CITY OF LEWISTON
PLANNING BOARD MEETING
Monday, July 28, 2014 – 5:30 P.M.
City Council Chambers – First Floor
Lewiston City Building
27 Pine Street, Lewiston

TO: Planning Board
FROM: David Hediger, City Planner
DATE: July 24, 2014
RE: July 28, 2014 Planning Board Agenda Item IV(a)

TO: Planning Board
FROM: David Hediger, City Planner
DATE: July 24, 2014
RE: July 28, 2014 Planning Board Agenda Item IV(b)

BATES LEWISTON RESPONSE

C2.0

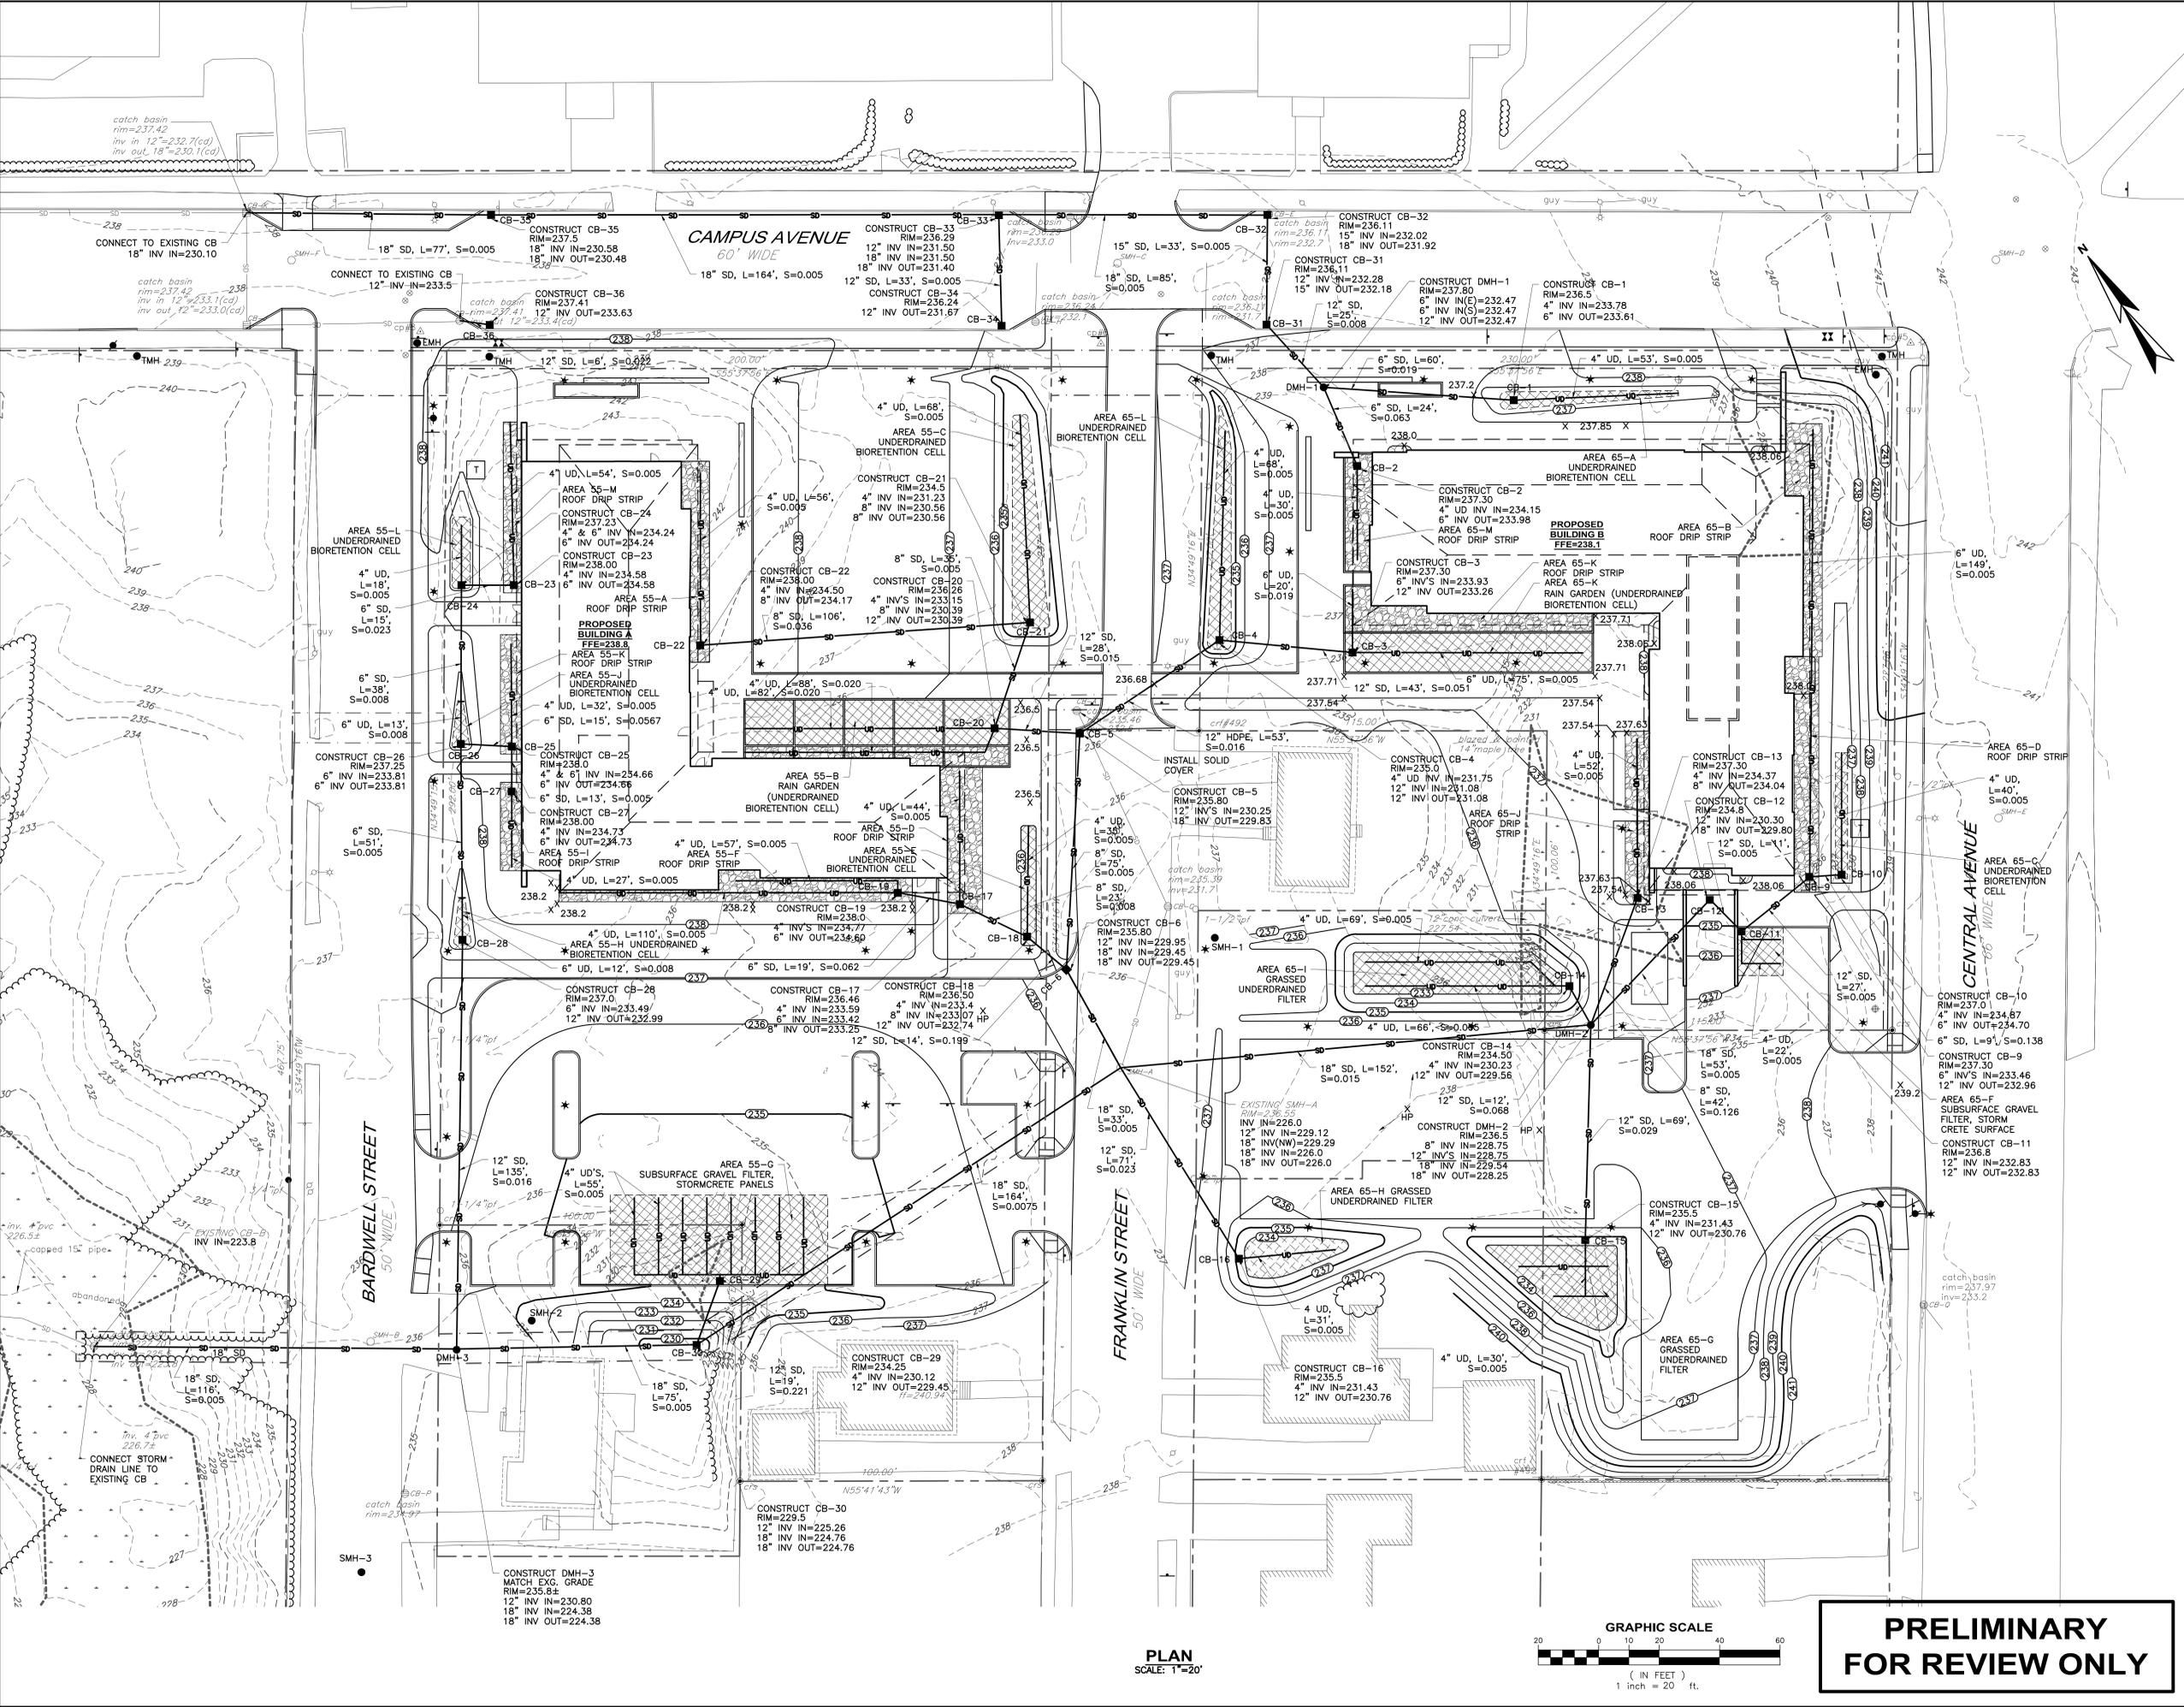
1. Sheet C2.0 – Proposed Conditions Site Plan

Please add the proposed cross walks, ADA Ramps, and appropriate signage to Campus Avenue for the proposed Campus Avenue Crossings.

Please show proposed signage associated with the discontinuance of Franklin Street.

Response: See revised drawing C2.0 for added cross walk, ADA Ramp and signage information at the Campus Avenue crossings.

Response: See revised drawing C2.0 for added signage at the ends of the closed portion of Franklin Street.

C2.1

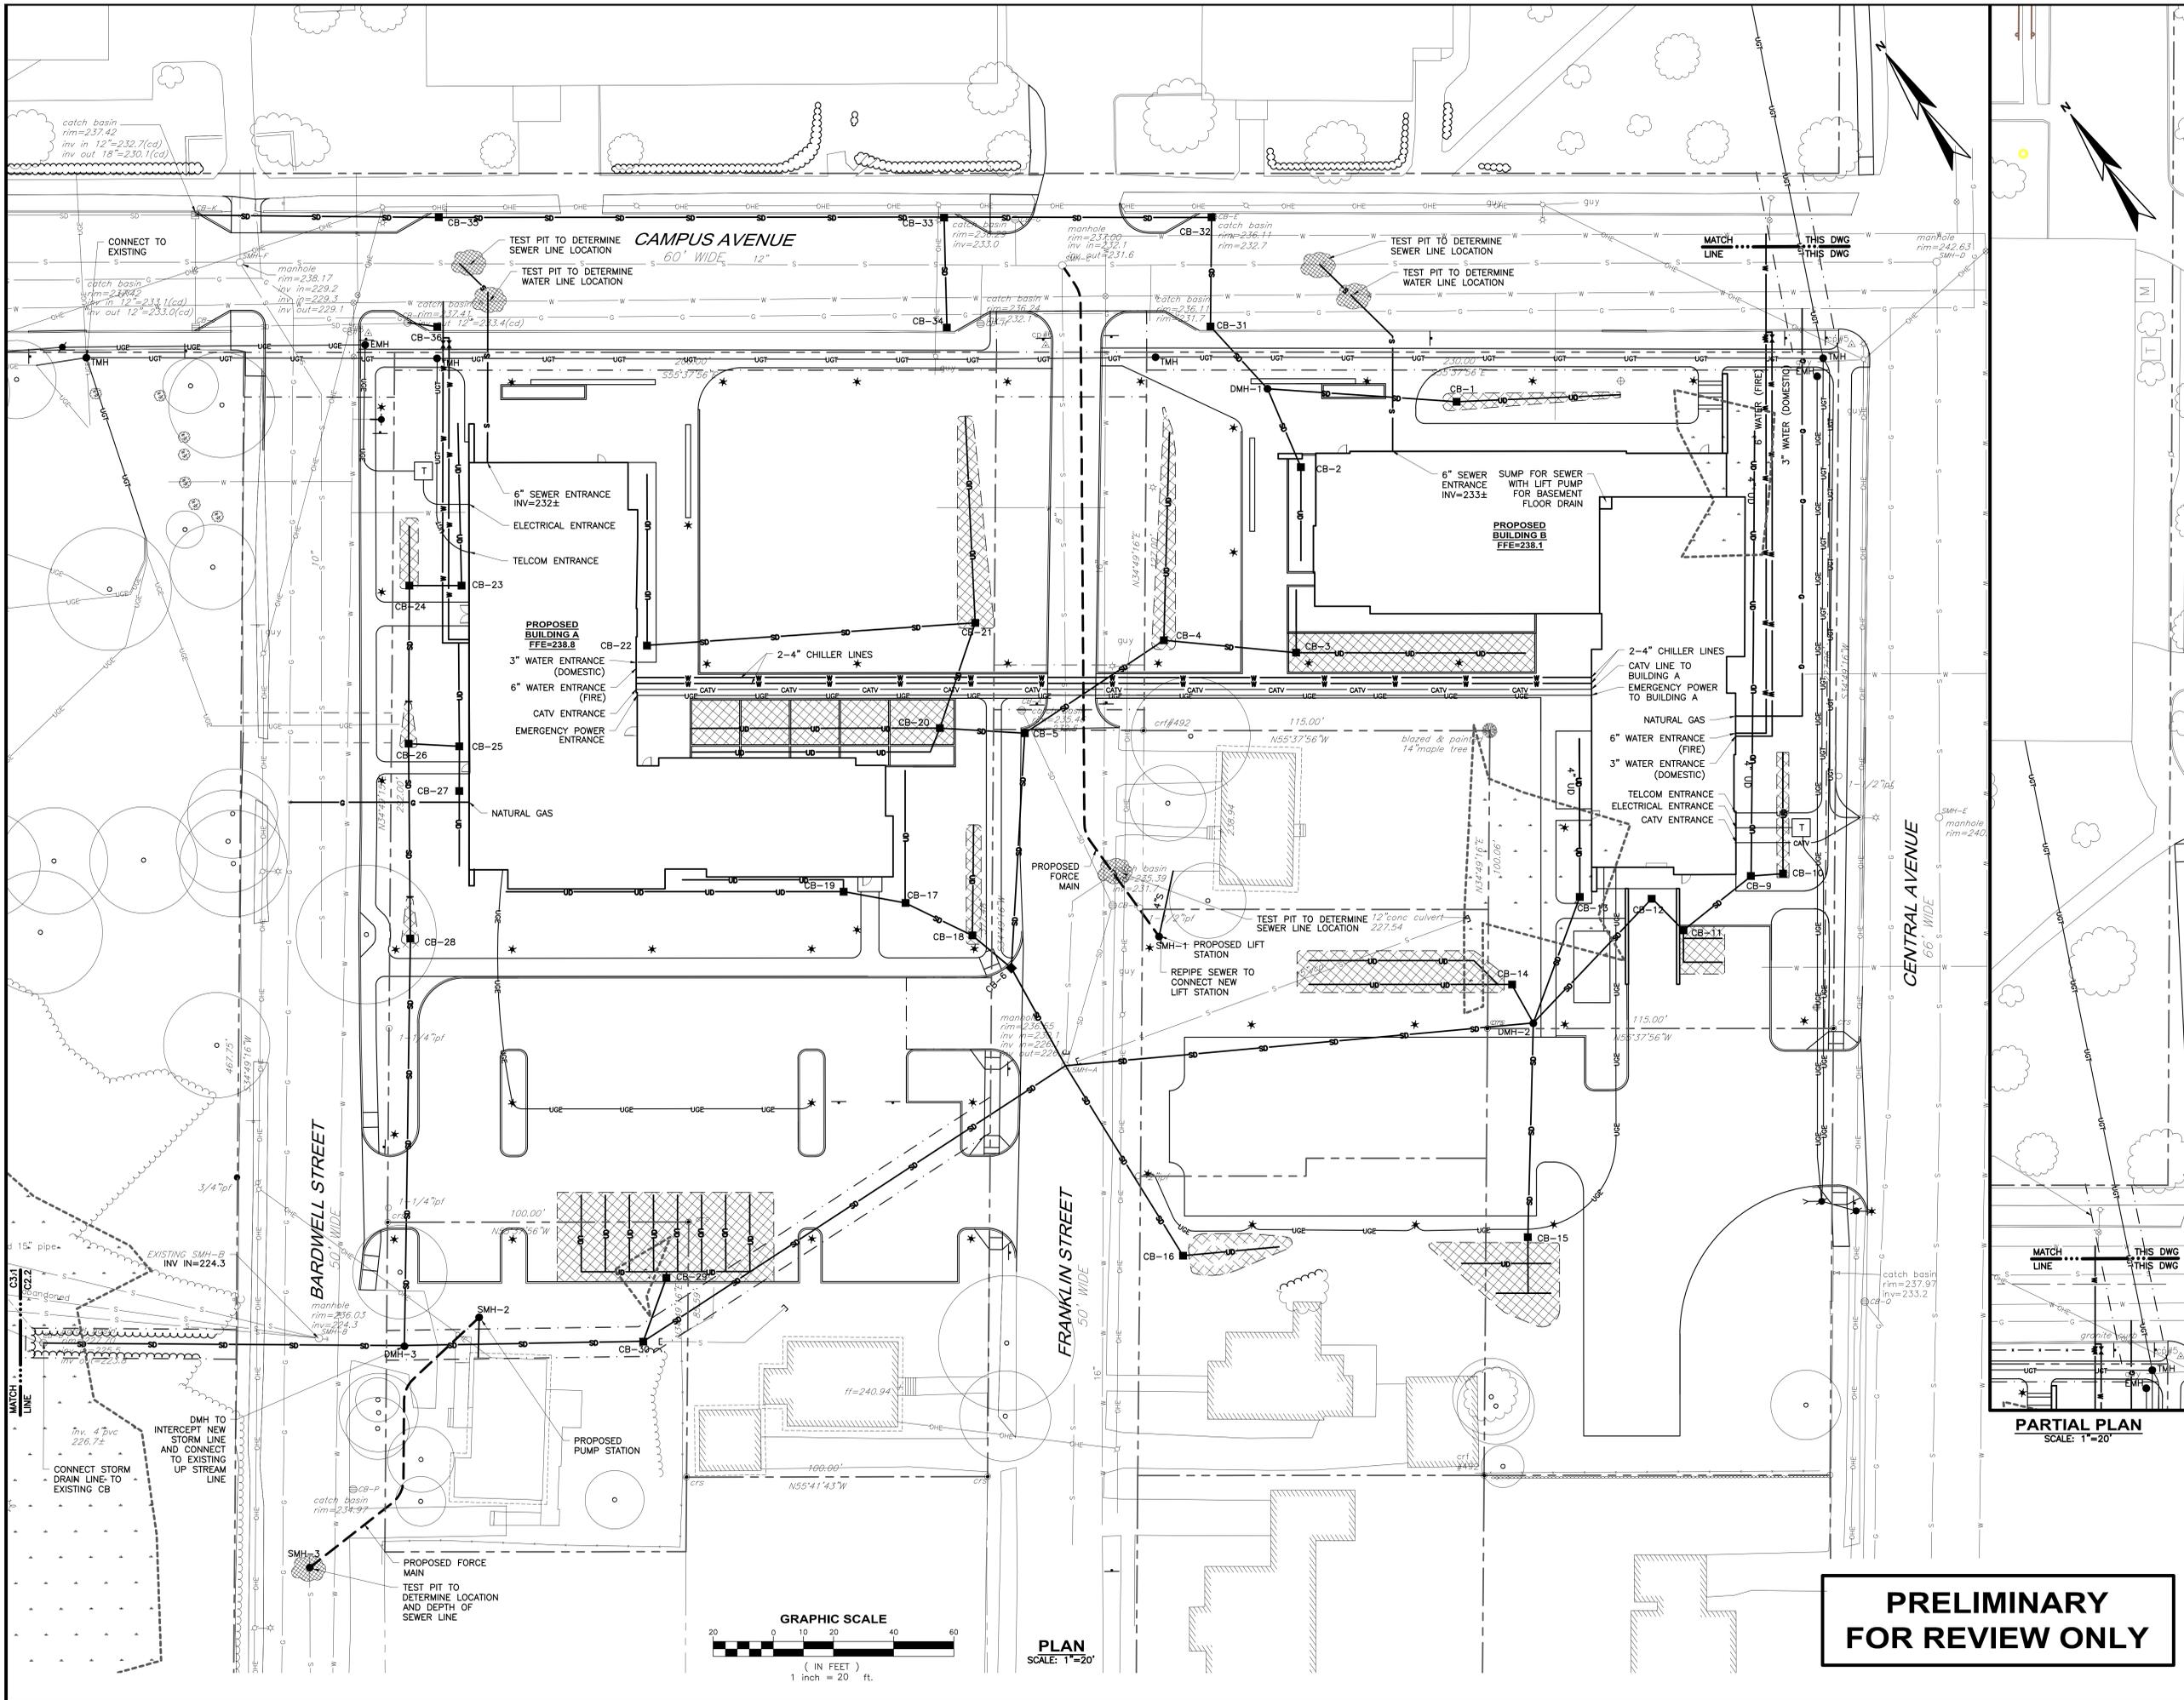
- **Sheet C2.1:** grading behind 101 Franklin is not the same as shown on grading easement in application. Please address. Need to ensure water does not impact abutting property owner.
Response: The grading on the 101 Franklin Street property, for which the easement applies, is the same in the exhibit as in the plan. The grading outside the 101 Franklin Property has been revised to respond to changes in the site plan since the easement exhibit was prepared. The site will drain to the vegetated soil filter south of the 101 Franklin property which meets the intent of the easement.

CAST IRON HANDICAP DETECTABLE WARNING PLATE
NTS

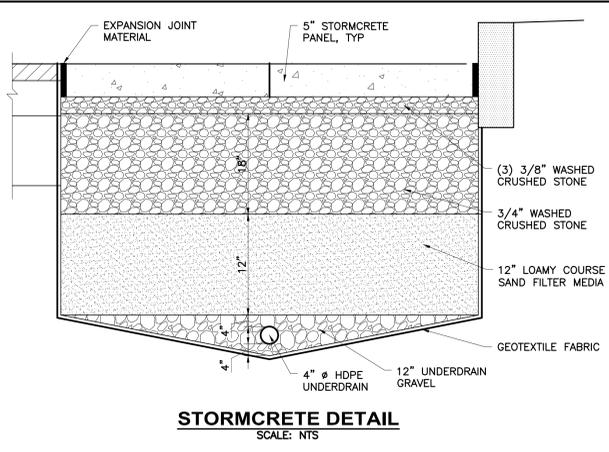
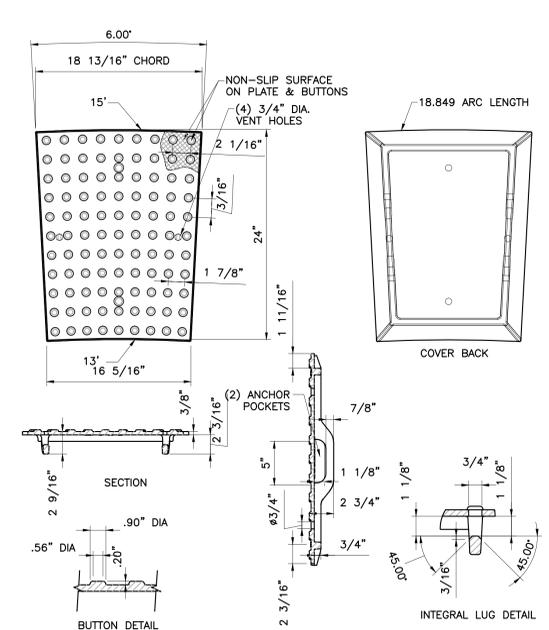
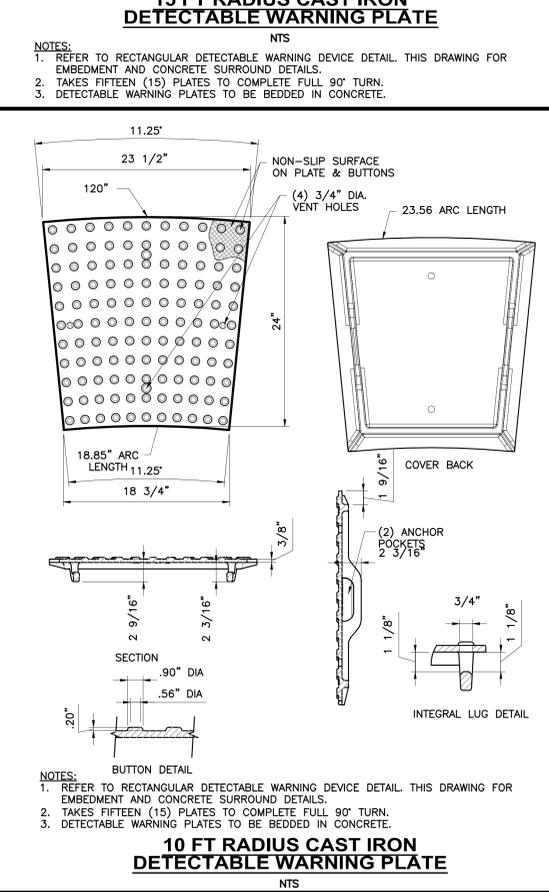
3. Sheet C3.1 – Details II

The Cast Iron Handicap Detectable Warning Plate detail should be revised to indicate that it shall be bedded in concrete.

Response: The detail has been revised to indicate that the plate is bedded in concrete.

(TEMPORARY, TO BE REMOVED PRIOR TO FINAL SITE PAVING)
STABILIZED CONSTRUCTION ENTRANCE
SCALE: "NTS"

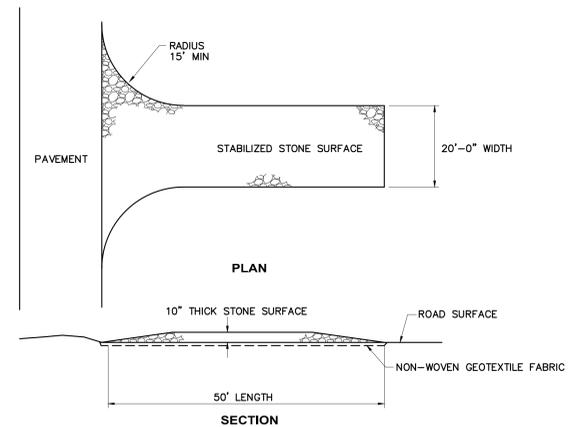
4. Sheet C3.2 – Erosion Control Details

The Stabilized Construction entrance should be revised to include geotextile fabric. **Response:** The detail has been revised to include geotextile fabric.
